## HISTORIC AND DESIGN REVIEW COMMISSION

**HDRC CASE NO:** 2022-150  
**ADDRESS:** 504 KING WILLIAM  
**LEGAL DESCRIPTION:** NCB 749 BLK 8 LOT 9,10, NW IRR 28.2FT OF 1 & NW 61.2 FT OF 2  
**ZONING:** RM-4, H  
**CITY COUNCIL DIST.:** 1  
**DISTRICT:** King William Historic District  
**APPLICANT:** Daniel Cruz/Design Coop  
**OWNER:** Christopher Guerra/LAUREL HEIGHTS FAMILY IRREVOCABLE TRUST  
**TYPE OF WORK:** Installation of a wood pergola in the rear yard  
**APPLICATION RECEIVED:** February 28, 2022  
**60-DAY REVIEW:** Not applicable due to City Council Emergency Orders  
**CASE MANAGER:** Jessica Anderson

1. Install a wood pergola on the rear balcony.
2. Install a wood pergola at the rear elevation.

**Historic and Design Review Commission**  
***Design Review Committee Report***

**SITE PLAN:** LANDSCAPE PLAN  
SCALE: 1/16" = 1'-0"

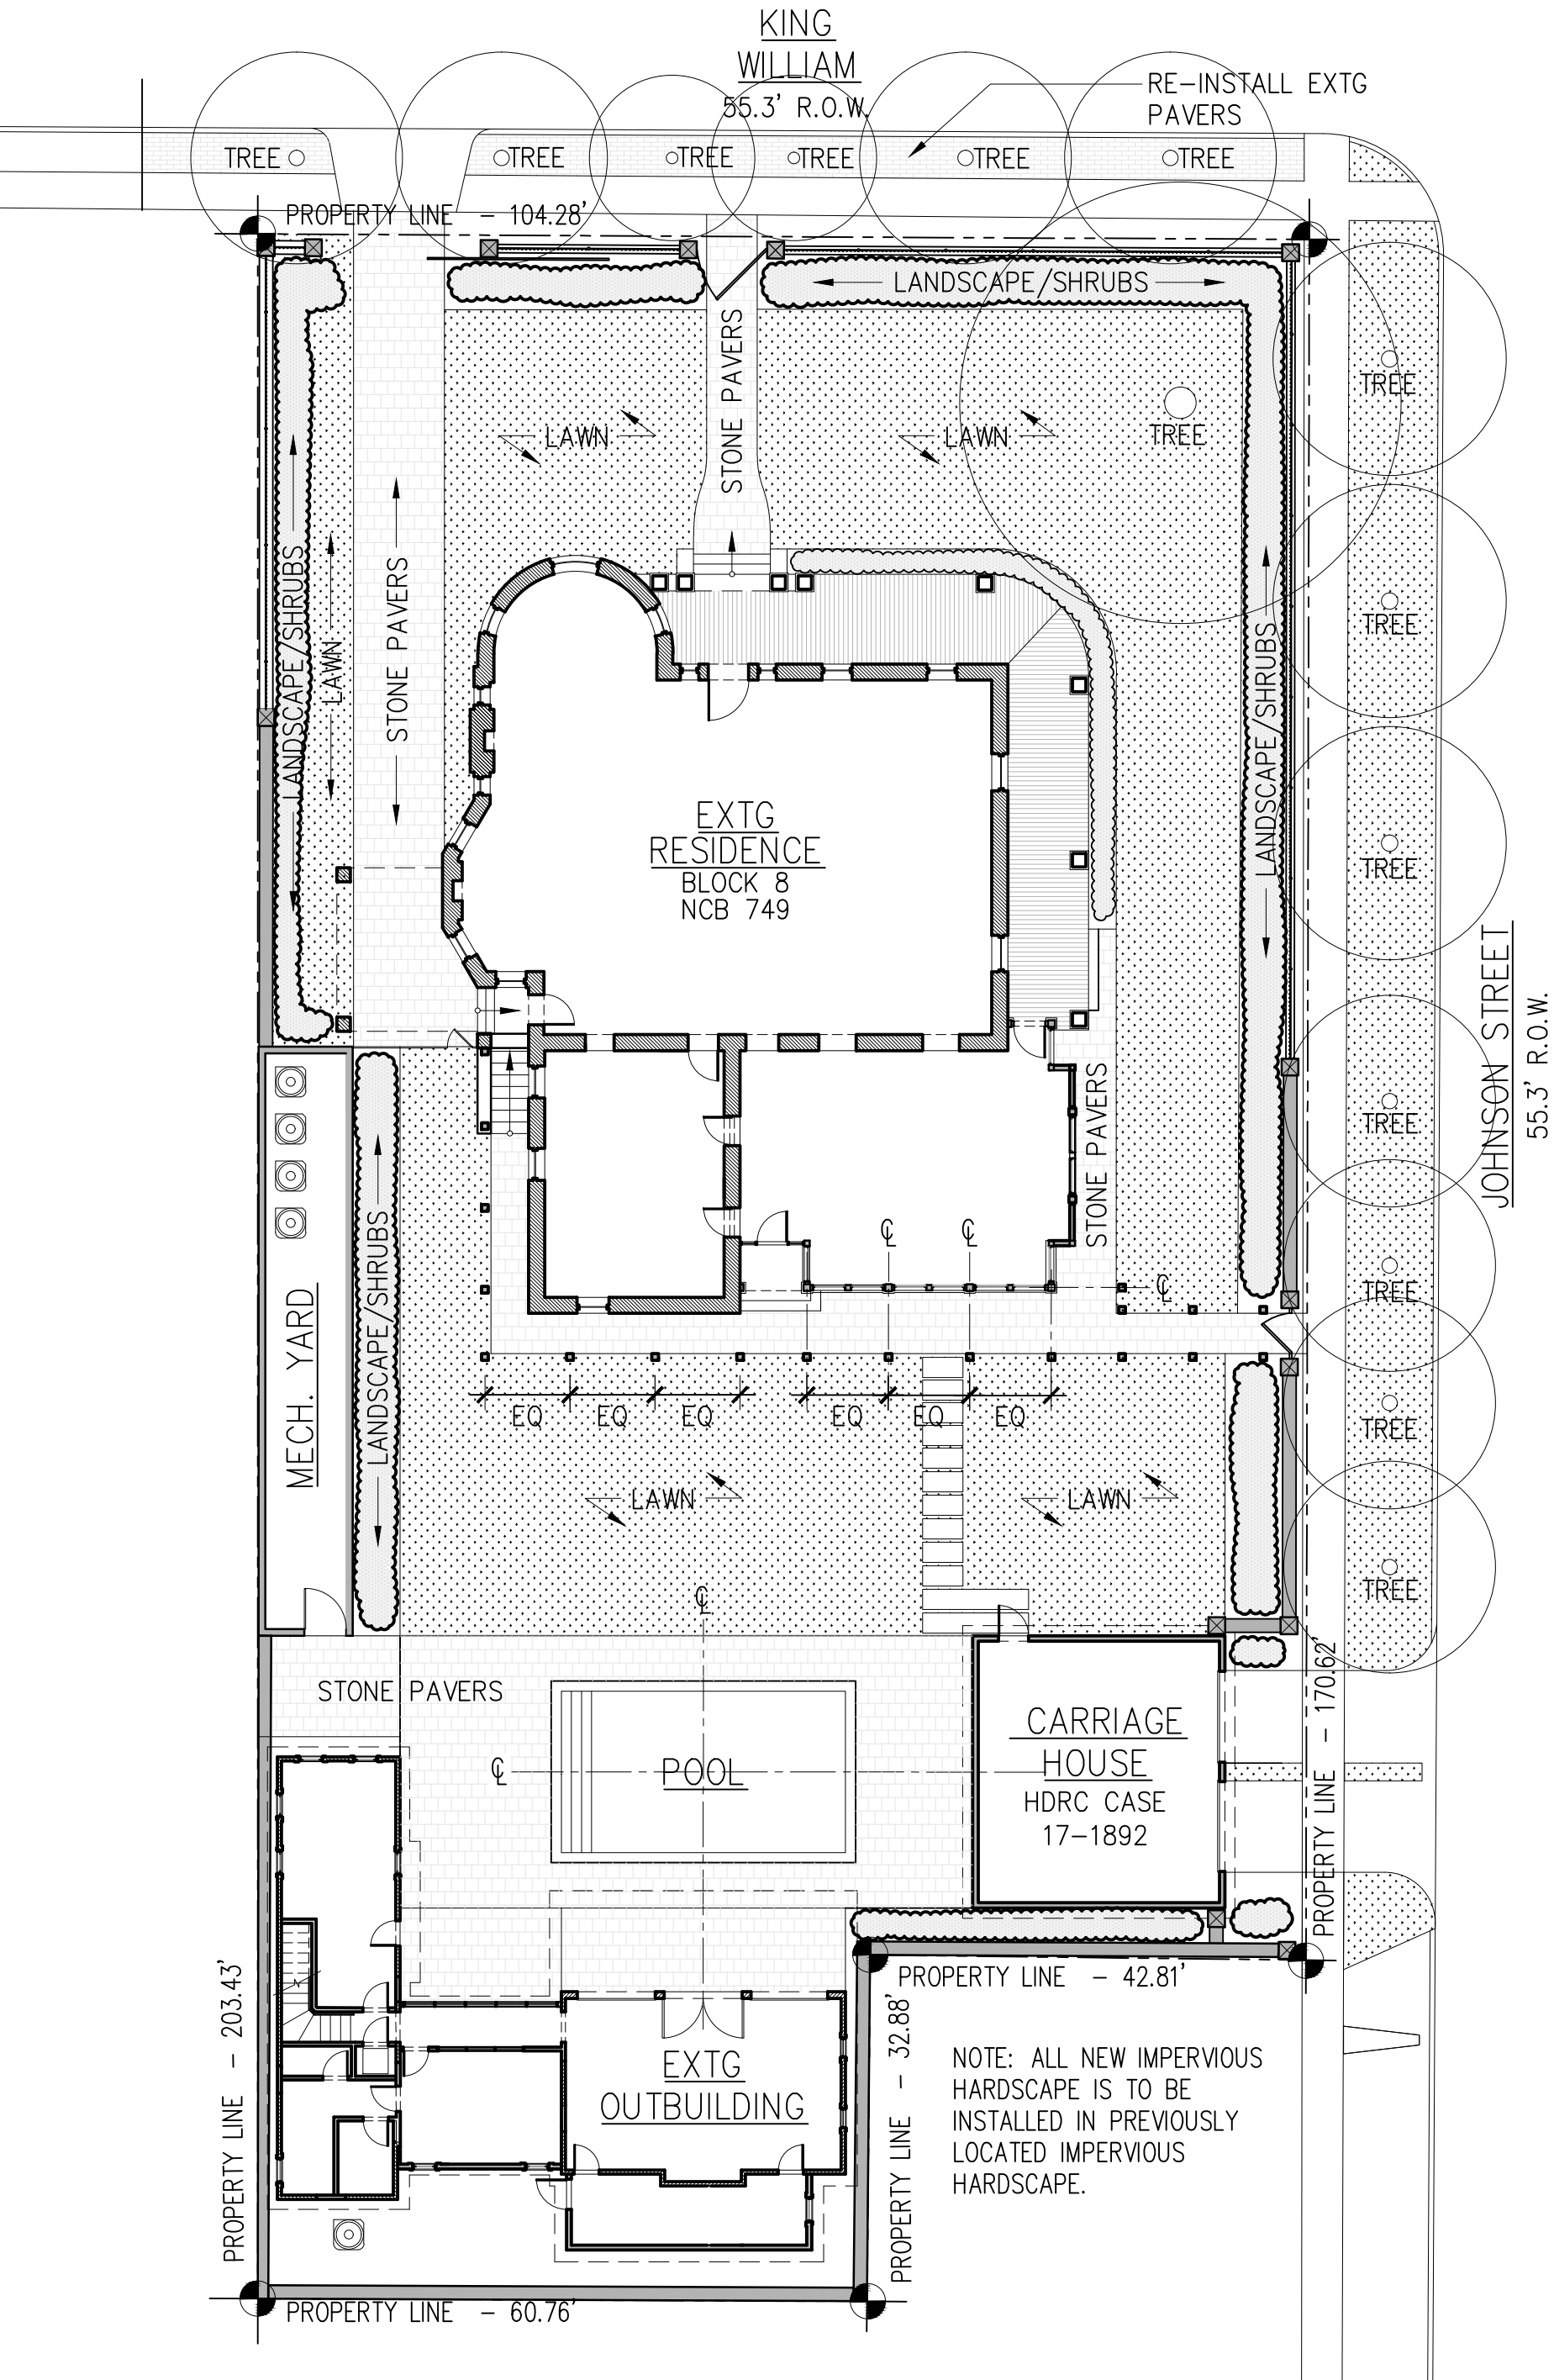
be reduced by more than 50%. The applicant has not provided the total percentage of lot coverage for review. Additionally, the applicant has not provided a landscaping plan showing the proposed site work. Staff finds that the applicant should submit lot coverage information and a landscaping plan showing the material and dimensions for all proposed site work to staff for review. Staff finds that the requested pergola is appropriate if the condition is reversible and is an independent structure not attached to the primary historic structure.

Cruz: We'll make some changes to upper pergola and provide some additional information. We'll also provide a landscape plan.

## PARTIAL SITE PLAN: PROPOSED PERGOLA AT FIRST FLOOR

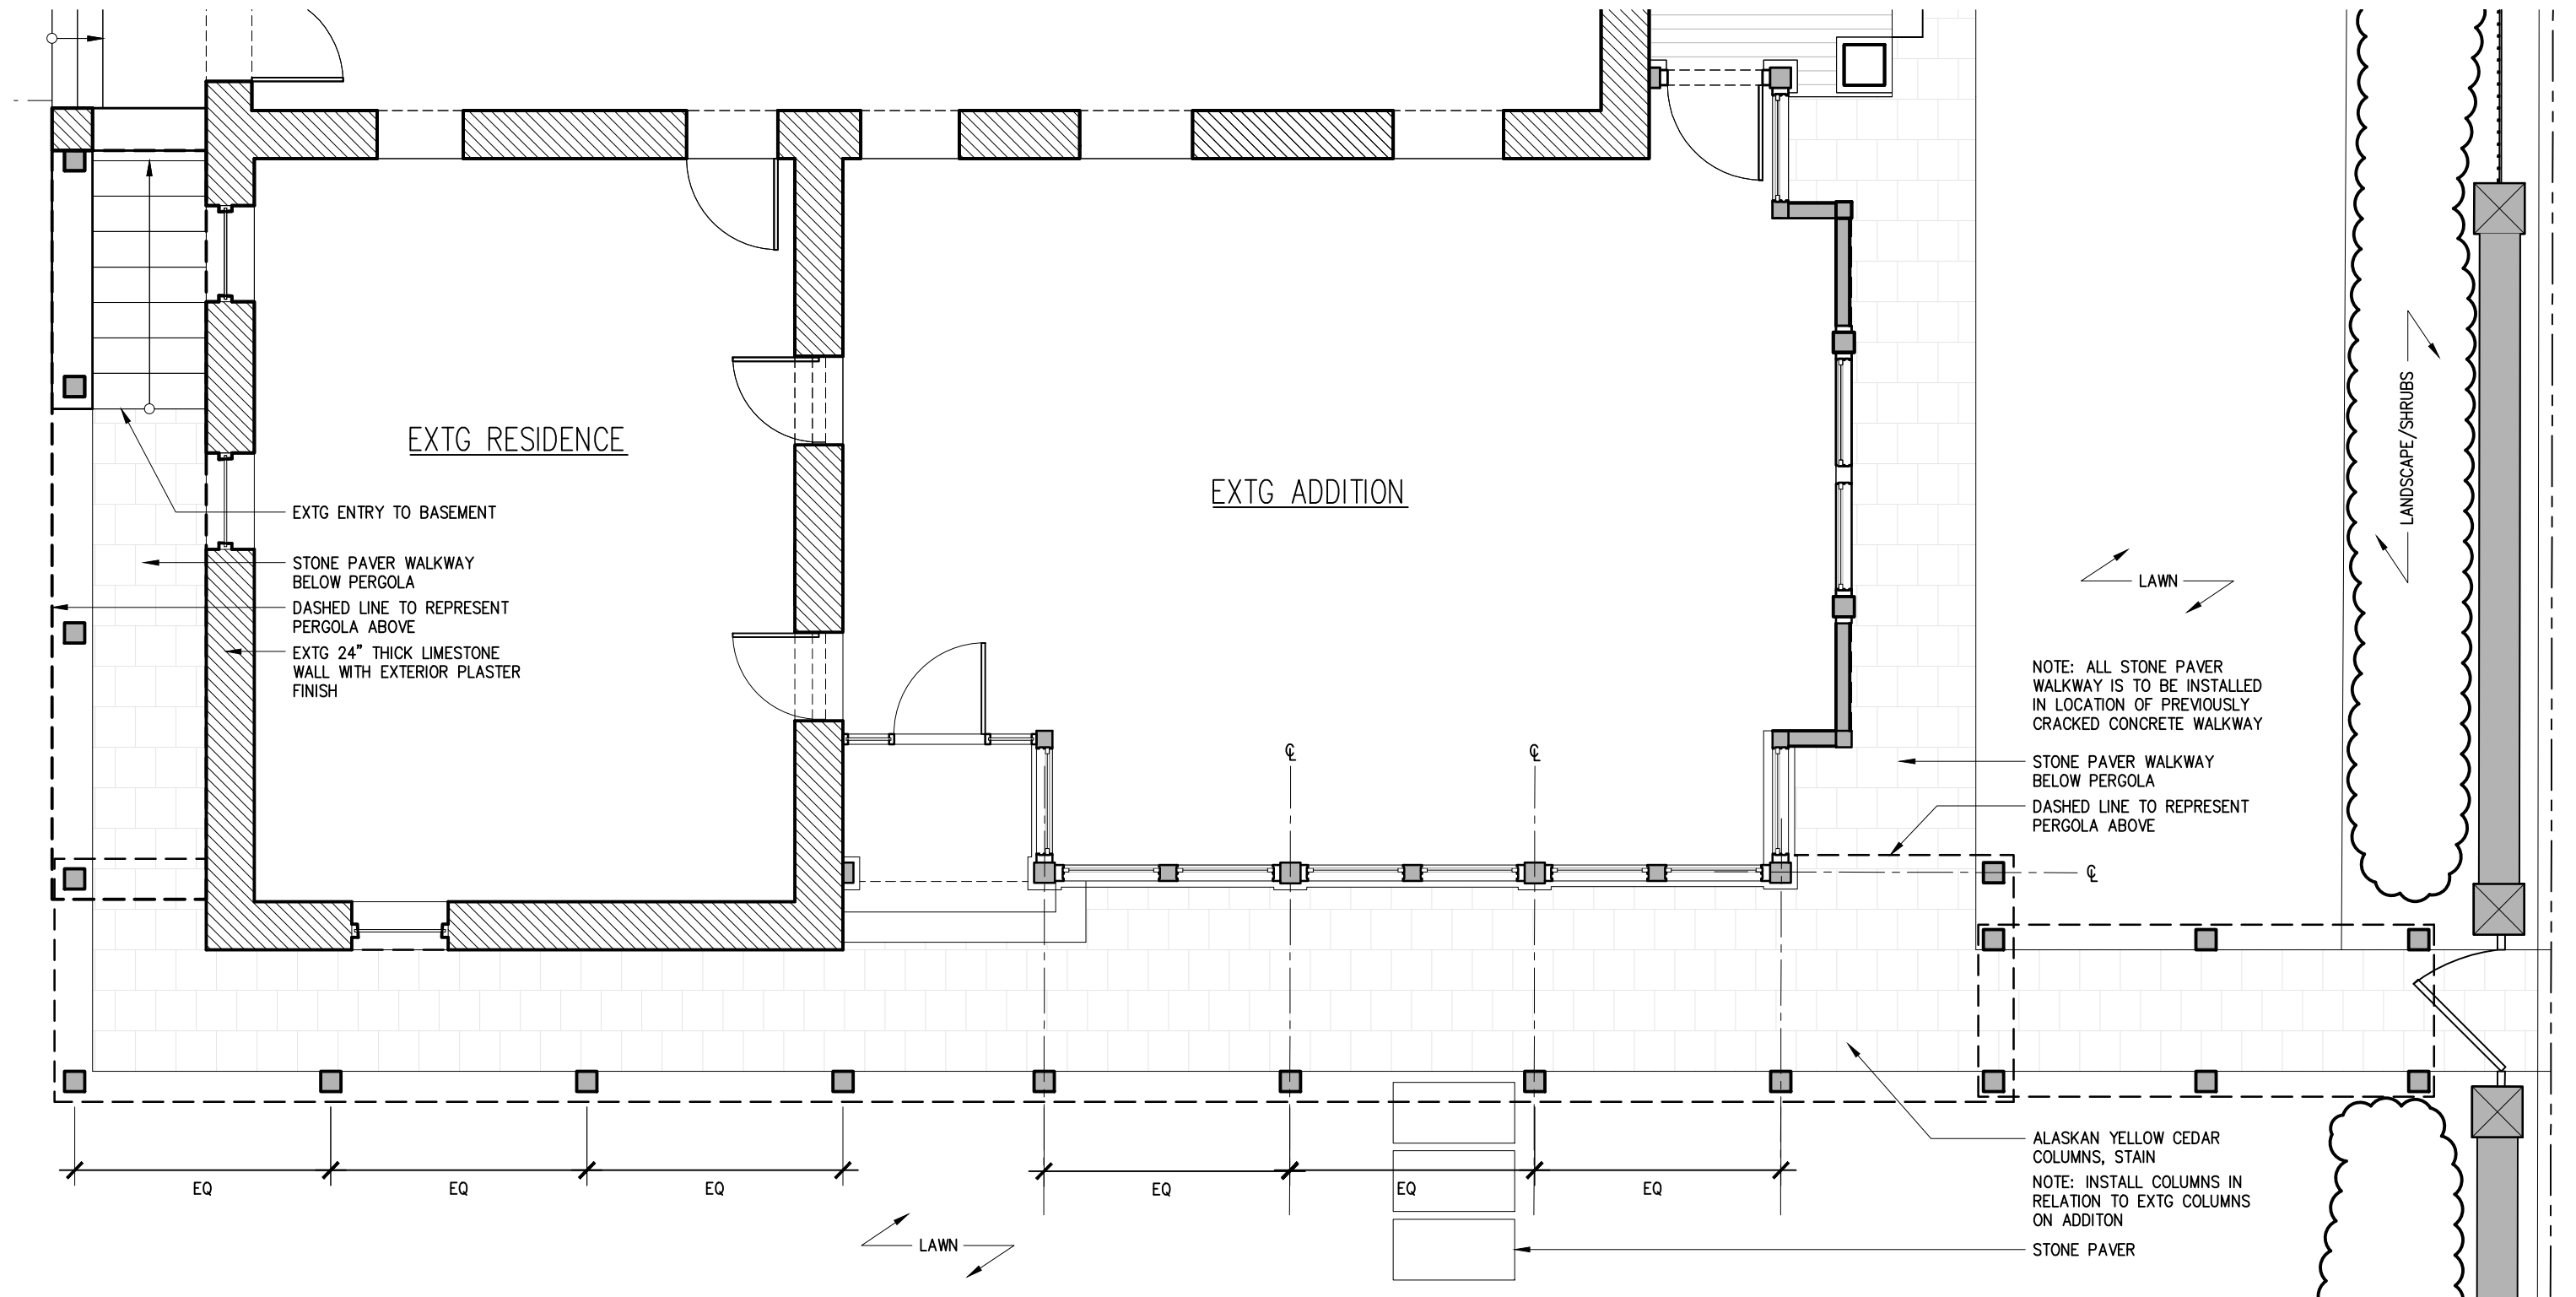
- d. REAR YARD: PERGOLA INSTALLATION – The applicant has proposed to install a pergola in the rear yard along the east (rear) elevation. The proposed pergola is 10 feet in height at the Johnson Street rear pedestrian gate and extends to 13 feet in height. The applicant previously proposed a pergola 10 feet 6 inches in height extending to 13 feet 6 inches in height, but has since reduced the height per DRC feedback. The proposed pergola will total 560 square feet and will connect to the primary structure with a ledger block and threaded rod. The applicant has proposed to install a stone paver walkway beneath the pergola structure. Guideline 3.B.i for Site Elements states that large pavers or other impervious surfaces should not be introduced where they were not historically located. Guideline 3.B.ii for Site Elements states that new pervious hardscapes should be limited to areas that are not highly visible and should not be used as wholesale replacement for plantings. According to Guideline 3.A.ii for Site Elements, do not fully remove and replace traditional lawn areas with impervious hardscape. Limit the removal of lawn areas to mulched planting beds or pervious hardscapes in locations where they would historically be found, such as along fences, walkways, or drives. Low-growing plantings should be used in historic lawn areas; invasive or large-scale species should be avoided. Historic lawn areas should never

**PARTIAL SITE PLAN:** PROPOSED PERGOLA AT SECOND FLOOR  
 SCALE: 3/16" = 1'-0"

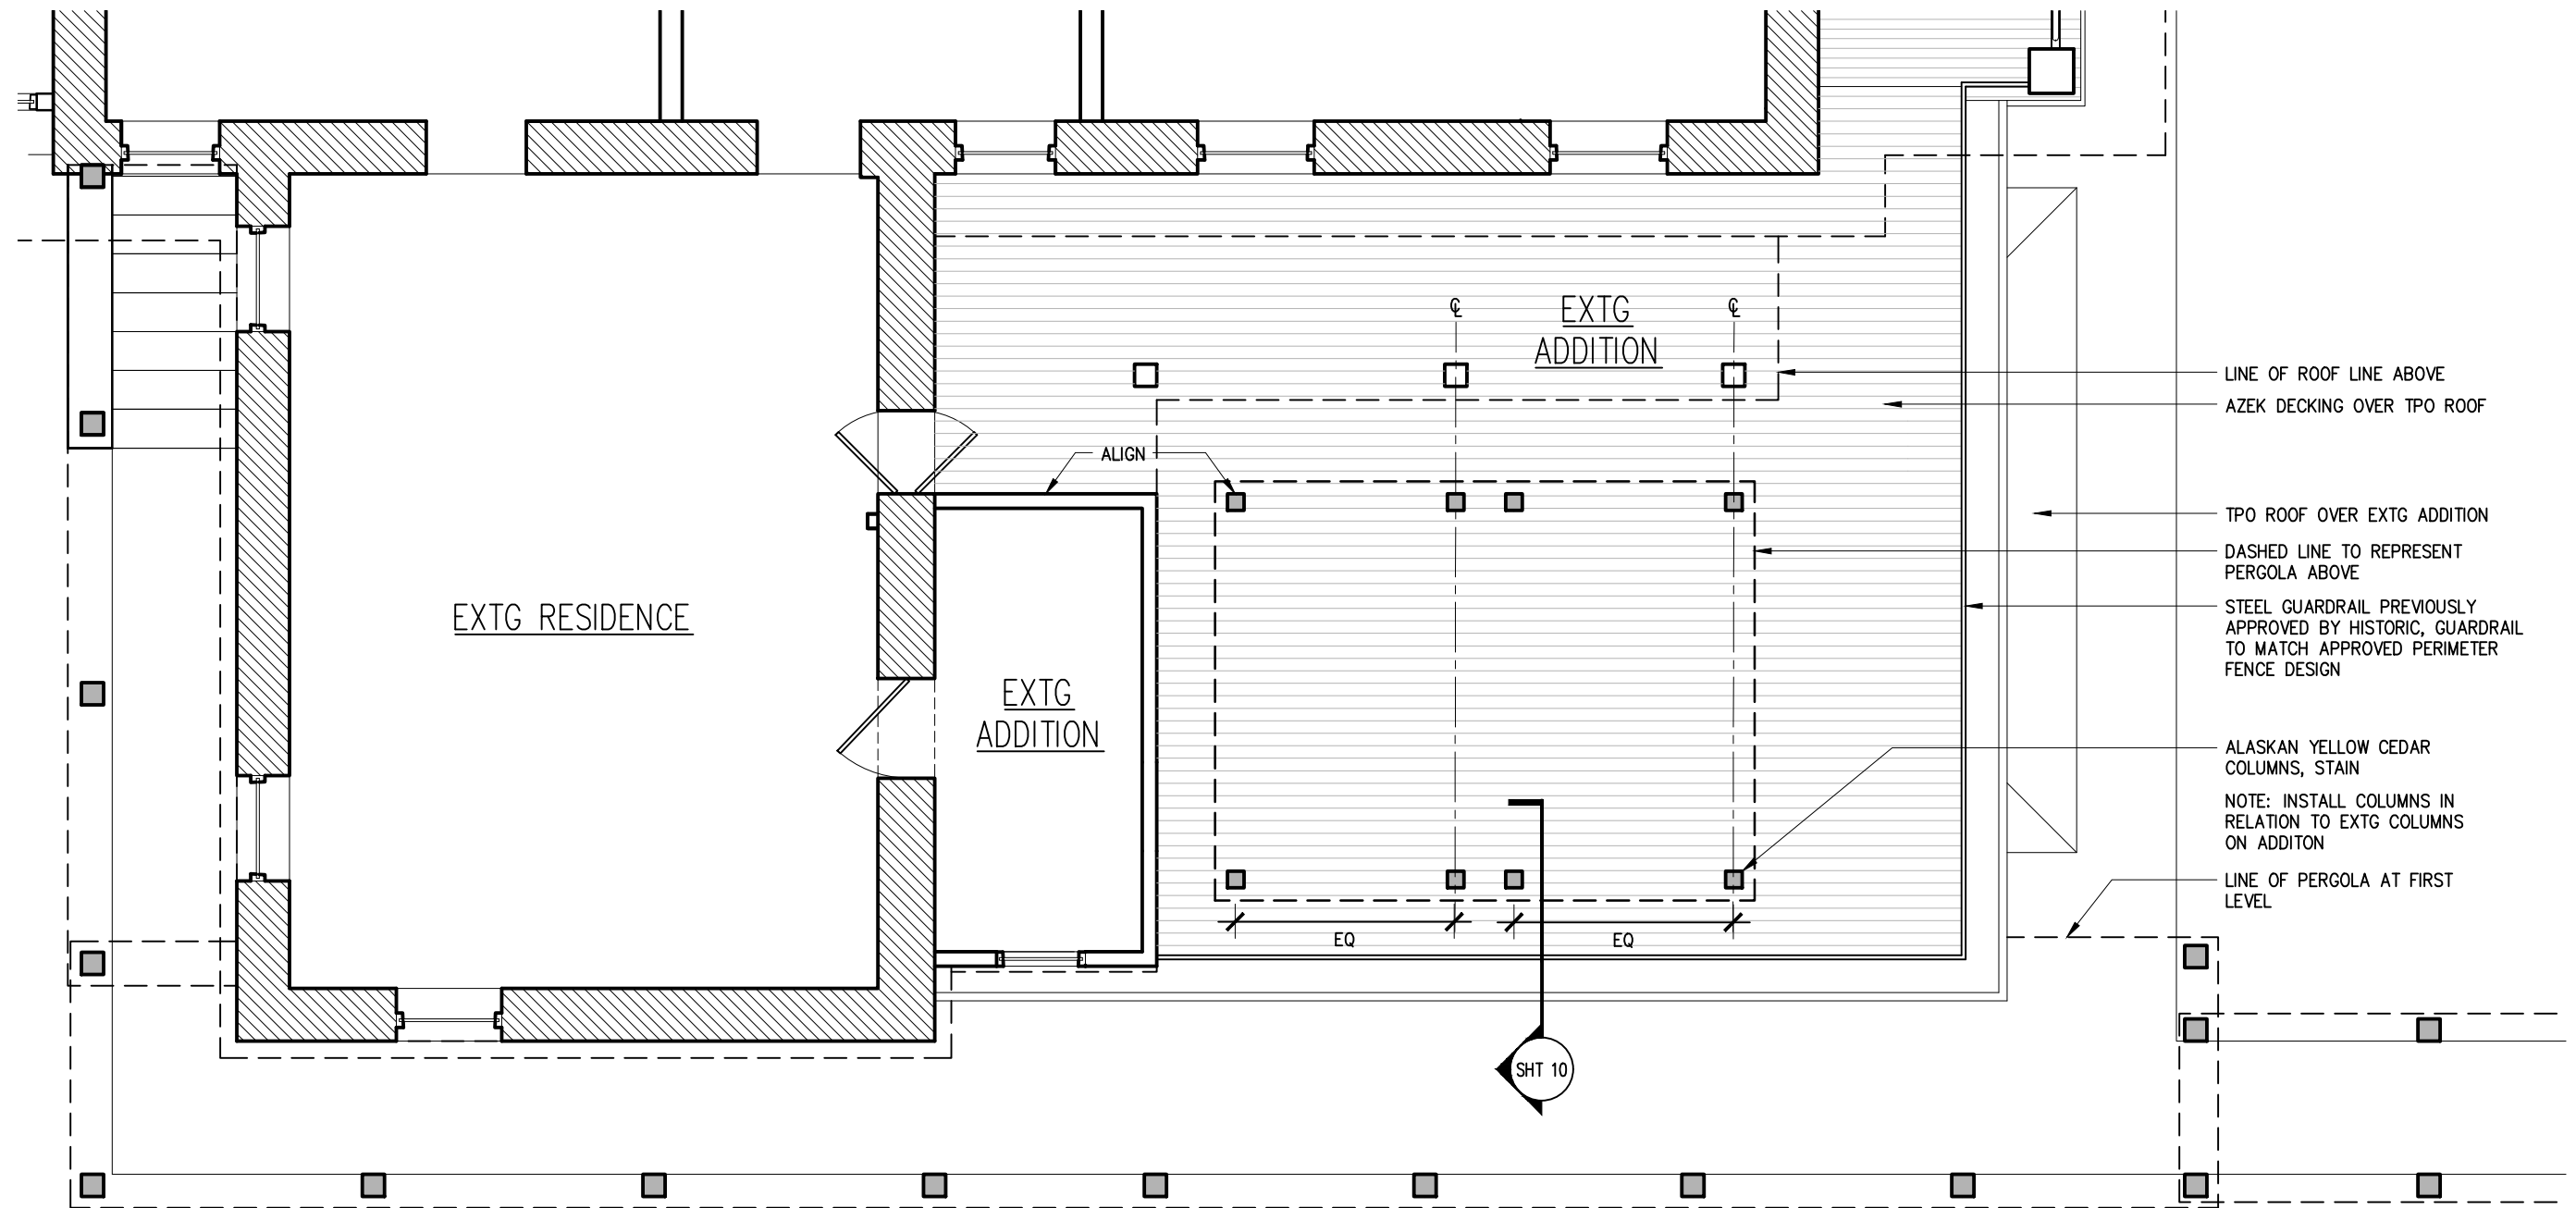
- c. REAR BALCONY: PERGOLA INSTALLATION – The applicant has proposed to install a fully wood pergola on the rear balcony. The proposed balcony pergola is 10 feet in height and will total 235 square feet. The applicant previously proposed a pergola 11 feet in height with the same footprint, but has since reduced the height per DRC feedback. The proposed pergola will connect to the primary structure with a ledger block and threaded rod. According to Guideline 1.A.i for Additions, residential additions should be located at the side or rear of the building whenever possible to minimize views of the addition from the public right-of-way. An addition to the front of a building would be inappropriate. The balcony pergola will be visible from the public right-of-way but will not detract from the architectural character of the building. Staff finds that the request is appropriate if the condition is reversible and is an independent structure not attached to the primary historic structure.

Savino: Size, scale of wood members—some are greater than the porch covering on main house. Begins to compete with existing arch elements. Maybe pergola is different, smaller, alternative design to pergola on second floor—might make a more hierarchical sequence of coverings.

Cruz: Rear balcony pergola was approved 1.5 years ago with metal awning/canopy. Homeowners wanted to pursue wood pergola—decided to change design of upper pergola as well. In terms of scale, understand—could adjust slightly and lower overall elevation of upper pergola. That is acceptable. Overall, we want to pursue design on upper floor.
